Change of plastic material from PBT+PC to PBT (Fuseholder and voltage selector)

Product Change Notification					PCN Fusedrawer 2		
owner	creation date	release date	released by	change order no	rev	page	D10-017-137
sariooar	21.09.2017	22.09.2017	buerlral	2013754	C	1 of 3

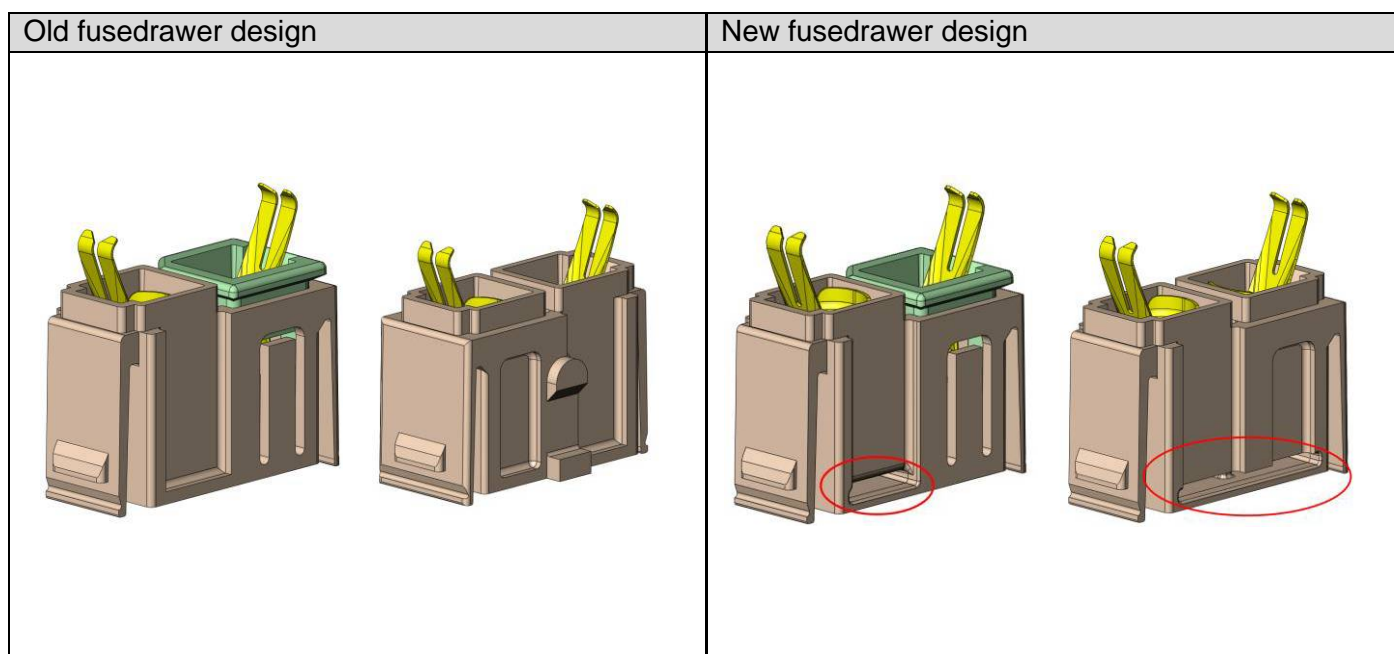
Change of fusedrawer design (additional air gap)

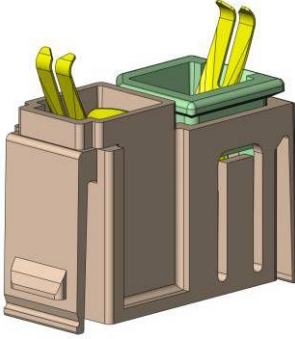
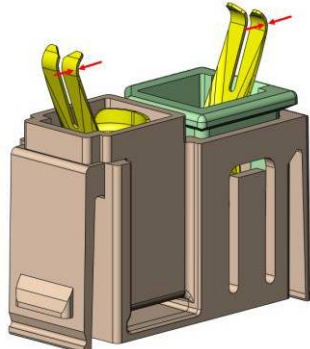
Old contact spring thickness 0.20 mm	New contact spring thickness 0.25 mm

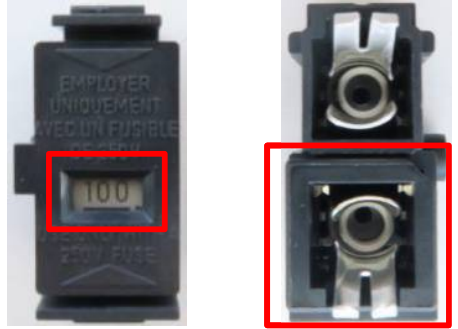
Old voltage selector insert white	New voltage selector insert changed to black colour

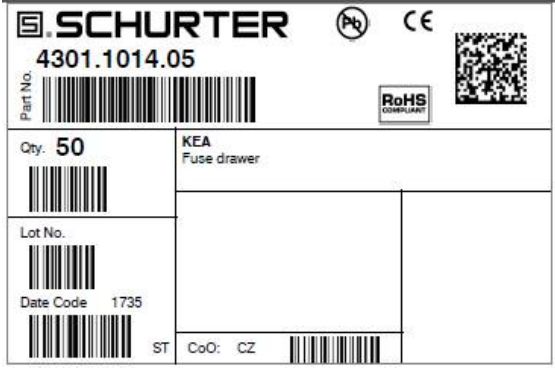
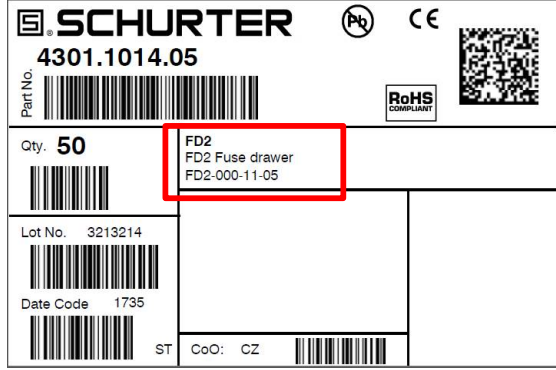
Old label	New label
	<p>Name and description adjusted. Configuration code added.</p>
